Keone Downing
Surfing Education Association
October 10, 2023

Subject: Formal Response to Right of Entry Request – PSF No. 23OD-079

I would like the board to DENY the Right of Entry permit submittal D-10 for the sand placement project proposed by Hilton Hawaiian Village, LLC.

Figure 3. Photographs of backshore flooding resulting from high tides and south swell

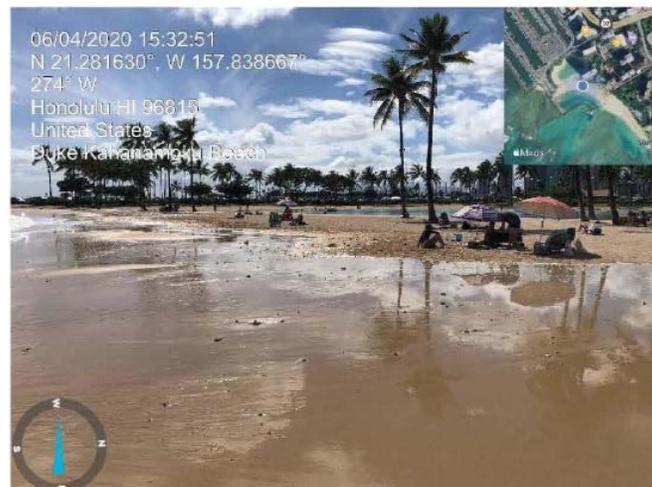
3a. The staff submission claims backshore flooding but only provides pictures of high tide wash (see pictures).

- Could you provide additional documentation or studies supporting the claim of backshore flooding?

The pictures depict high tide wash, not 'backshore flooding' as referred to in the submittal.
